# SUBMISSIONS REPORT

SSDA-10448 Mod 2  
Aspect Industrial Estate

Prepared for  
**MIRVAC**  
23 September 2022

This Submissions Report relates to Modification 2 to the Aspect Industrial Estate (**AIE**) Development (SSD-10448) at 804-882 Mamre Road, Kemps Creek (**the site**). On behalf of Mirvac Projects Pty Ltd (**the Applicant**), this Submissions Report has been prepared to address the matters raised by public agencies, local Council and other relevant stakeholders throughout the public exhibition period.

Figure 1 Refinement to Concept Masterplan - Warehouse 3

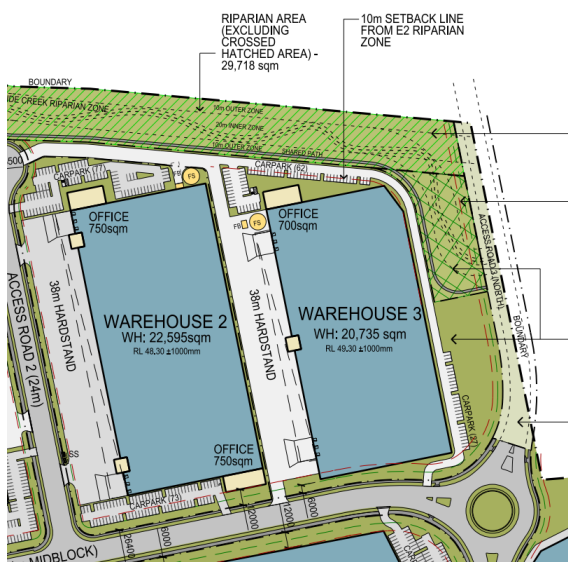
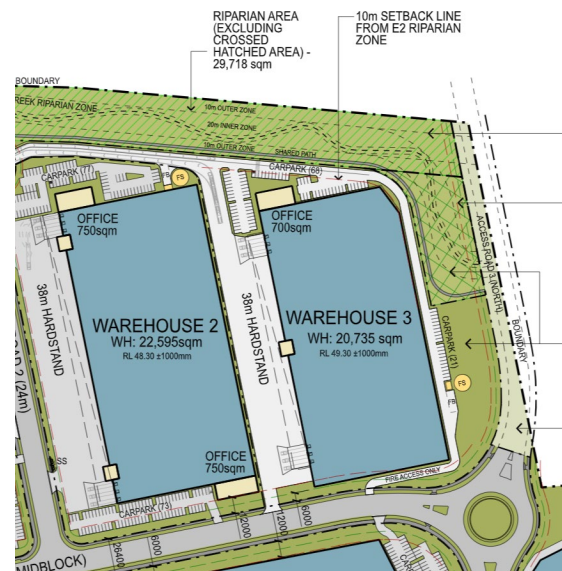
Location	Proposed Refinements
<b>Warehouse 3 Carpark Areas</b>	<ul style="list-style-type: none"> <li>Reduction of car parking spaces at the east carpark area from 27 to 21 (reduction of 6 spaces).</li> <li>Increase in car parking spaces at the north carpark from 62 to 68 (increase in 6 spaces).</li> <li>Re-alignment of the east carpark space further north (closer towards the main office).</li> <li>Re-alignment of the northern carpark layout if accommodate increased number of spaces.</li> </ul>
<b>Warehouse 3 Pedestrian Access</b>	<ul style="list-style-type: none"> <li>New, dedicated pedestrian path that travels parallel to the north driveway, connecting access road 2 and the main office.</li> <li>New, dedicated pedestrian path that travels along the southern, northern and eastern ends of Warehouse 3 that connects the east carpark with the main office.</li> <li>New, striped crossing that travels through the north carpark and driveway between the northern pedestrian path and the main office.</li> </ul> <p><i>The updated pedestrian access arrangements are shown in Figure 2 below.</i></p>

<b>Warehouse 3 Vehicular Access</b>	<ul style="list-style-type: none"> <li>Adjustments to the area and swept path from the western hardstand area into the connecting outbound driveway (connecting Warehouse 3 to Access Road 2). This provides for separated light (inbound and outbound) and heavy vehicle (outbound) access, and requires an adjustment to the lot boundary with Lot 2 resulting in <ul style="list-style-type: none"> <li>reduction in Lot 2 site area from 40,172sqm to 40,072sqm.</li> <li>Increase in Lot 3 site area from 42,755 to 42,855sqm.</li> </ul> </li> </ul>

Location	Proposed Refinements
	<ul style="list-style-type: none"> <li>Adjustments to the easternmost driveway alignment from the Access Road 1 cul-de-sac to Warehouse 3 and dedication to Fire Brigade Access only. This includes an additional access gate to control access to the southern, fire infrastructure area.</li> <li>Clear line demarcations for light vehicle and heavy vehicle access through the access driveway connecting Access Road 2 and Warehouse 3.</li> </ul> <p><i>The updated vehicular access swept paths and travel paths are demonstrated in Figure 1 below.</i></p>
<b>Warehouse 3 Fire Management Infrastructure</b>	<ul style="list-style-type: none"> <li>Re-location of the approved fire hydrant booster, sprinkler tank and dedicated fire truck parking area to the south-east corner of Lot 3.</li> </ul>
<b>Warehouse 3 Landscaping</b>	<ul style="list-style-type: none"> <li>Updated landscaping areas and vegetated islands around and throughout the updated, northern and eastern carpark layout.</li> <li>Adjusted landscaping layout across the southern end of Lot 1 in accordance with the driveway alignment from Access Road 1 to the eastern end of Lot 3.</li> </ul>

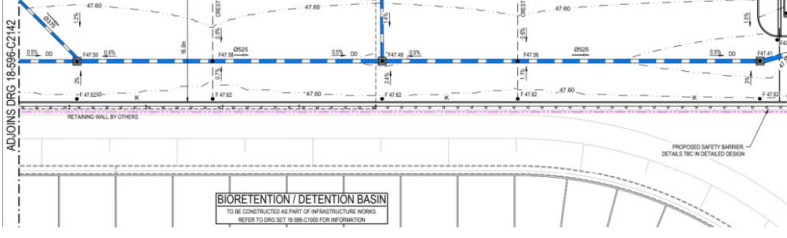
Summary of Issue Raised	Response	Supporting Document
<p>(d) The landscape master plans accompanying the application propose 18 x Spotted Gums being a mature height of 30m with a canopy spread of 8m.</p> <p>Spotted Gums shown on the Tree Planting Masterplan S1-1 001 Rev A are not indicated on the Lot 1 on-lot works landscape plans (refer S1-1_101 through 103 revision P and Figures below).</p> <p>Previously provided section through this area have been removed from the civil and landscape sets.</p> <div style="display: flex; justify-content: space-around; align-items: flex-end;"> <div style="text-align: center;">  <p><b>Figure 7:</b> Applicant's Landscape plan – Warehouse 1 – 05 refers to Spotted Gums</p> </div> <div style="text-align: center;">  <p><b>Figure 8:</b> Applicant's On-Lot Works Landscape plan – Warehouse 1 – Excerpt.</p> </div> </div>	<p>The plan and figure referenced in this commentary is outdated. This plan submitted to Penrith City Council is outdated and included in the application package by mistake.</p>	<p>N/A</p>

Summary of Issue Raised	Response	Supporting Document															
<p><b>Figure 9:</b> Civil plans indicating no space for canopy tree planting (refer 18-596-C2143 issue 1)</p> 																	
<p>Notwithstanding the above, trees are not achievable in the selected location upon review of the sections and owing to the location of the palisade fencing, the retaining wall, and the super awning above.</p>	<p>The refined landscape plans and masterplan has been prepared to be consistent with the latest architectural plans and civil drawings.</p>	<p><b>Appendix C</b></p>															
<p>Council strongly recommends that DPE require that the Aspect precinct achieve compliance with the minimum 10% canopy tree targets as is required under the Mamre Road Precinct DCP.</p> <p>Canopy trees previously approved in the Estate are significantly reduced by the amended plans which is not supported by Council. The resultant presentation of Warehouse 1 to Mamre Road is to be addressed and improved. The warehouse footprint is to be reduced to enable the provision of canopy trees, shrubs and along this elevation.</p>	<p>The refined landscape plans identify the updated Lot 1, 2, and 3 tree canopy coverage as part of MOD 2 compared to the approved SSD. The updated landscape plans generally accommodate an increase in the on-lot canopy coverage and the overall estate will continue to achieve compliance with the Mamre Road Precinct DCP.</p>
